SN65LVPE502A Application Note

The SN65LVPE502A redriver is a dual channel, single lane USB 3.0 redriver and signal conditioner supporting data rates of 5.0Gbps. All errata for the previous part, SN65LVPE502CP, are fixed in this device. This application note provides information on implementation of the SN65LVPE502A device based on changes from the SN65LVPE502CP device.

Figure 1 SN65LVPE502A Pin-Out

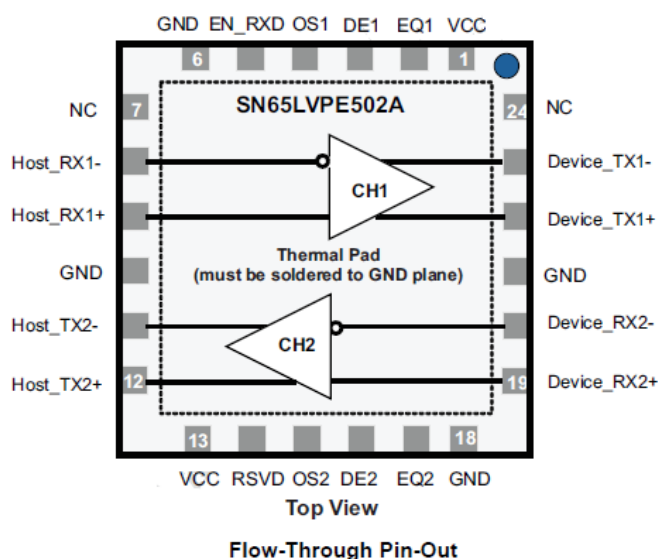
The host side and device side connections are now defined for the SN65LVPE502A device. Please reference Table 1 SN65LVPE502A Pin Functions, for a list of pin definition changes.

Figure 3 Connection of VBUS Powered Device

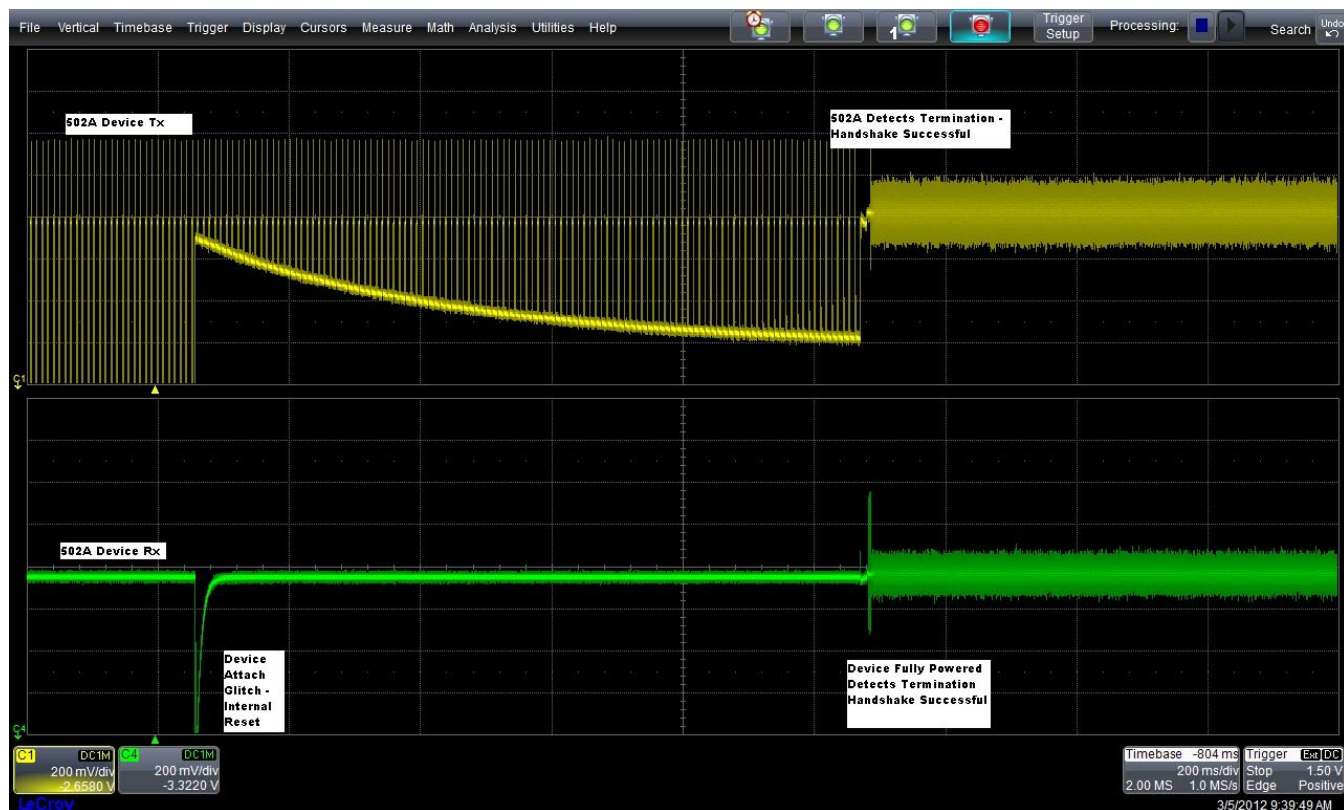
Some VBUS powered devices create noise on plug-in and cause the SN65LVPE502CP to falsely detect the device and enable termination early. After termination is enabled, the host begins polling before the device is ready. Polling will timeout and the host will enter compliance mode. This issue is fixed on the SN65LVPE502A device. Figure 2 Connection of VBUS Powered Device below shows a successful connection after a glitch is observed when the VBUS powered device is attached.

Figure 4 SN65LVPE502A Successful Disconnect

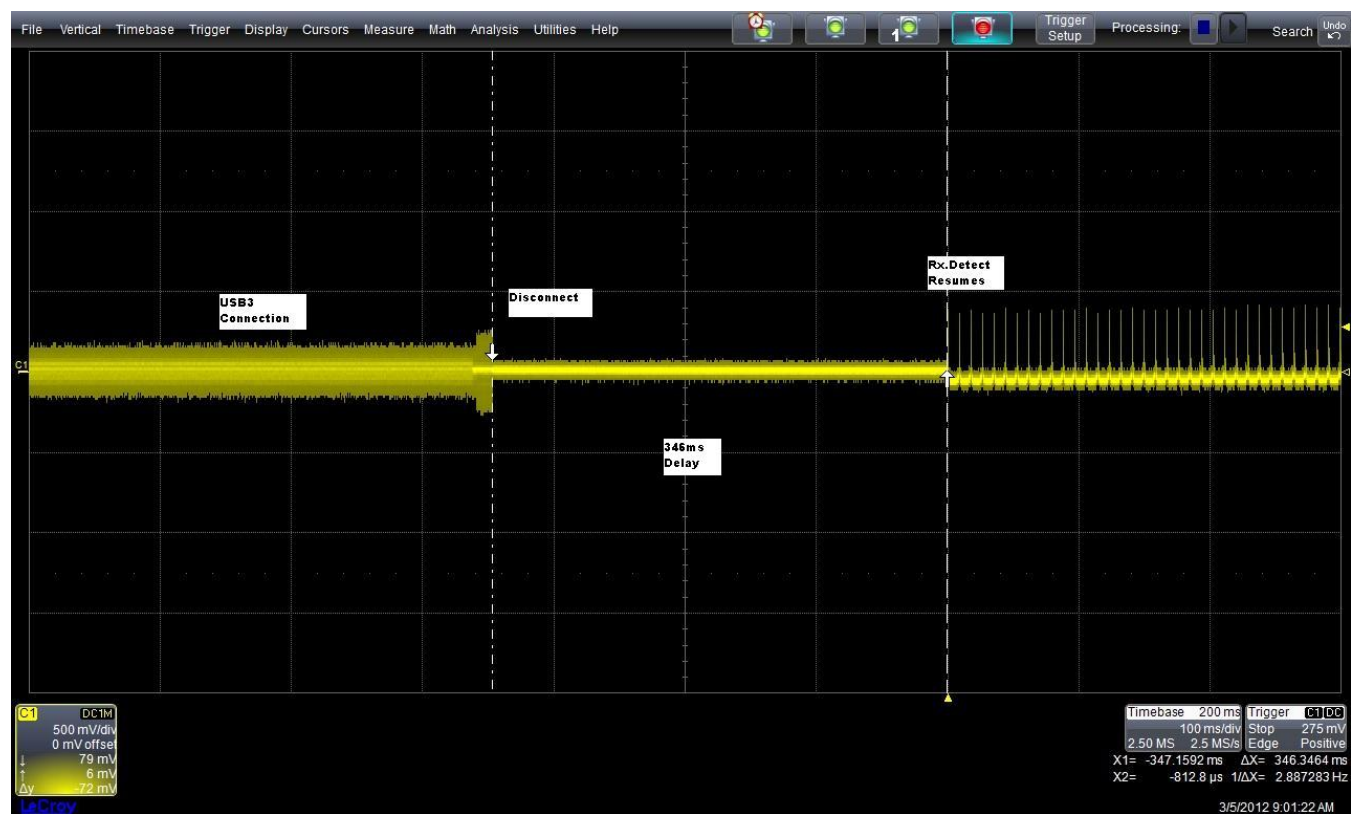
In certain conditions the termination remains enabled after a device is disconnected from the SN65LVPE502CP. This issue is host software driver dependant. If host issues a warm reset within ~300ms of device disconnect the termination will remain enabled. No functional issues are observed, but the power consumption is increased while no devices are connected. This issue is no longer driver dependant and is fixed in the SN65LVPE502A. A successful disconnect may be observed in Figure 3 SN65LVPE502A Successful Disconnect below.
